| 御中   |   | Issue No. / 発行№: PC-0025365   |                                   |               |       |
| <b>工程変更連絡書</b><br><b>Process Change Notice</b>   |   | ヒロセ電機株式会社<br>郡山工場 品質管理課<br>Koriyama Factory, Quality control section, Hirose Electric Co., Ltd. |                                   |               |       |
| 貴社品番/Customer's product number   |   | 弊社品番/Product number by Hirose<br>CL232-0010-5 56 (representative)                               |                                   |               |       |
|  |   | 弊社品名/Product name by Hirose<br>3260-8S3(56) (representative)                                    |                                   |               |       |

**Before a change**

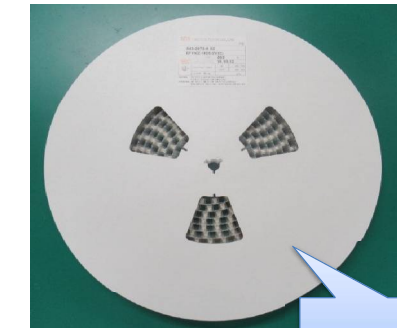
Flat on the lead

Paper reel

**After a change**

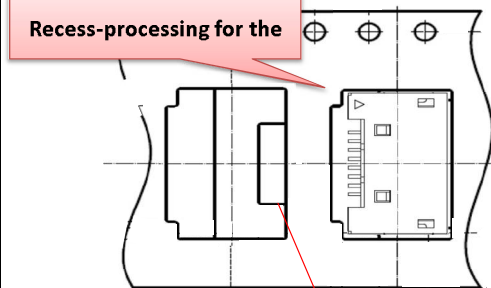
Recess-processing for the

The shape is

Plastic reel
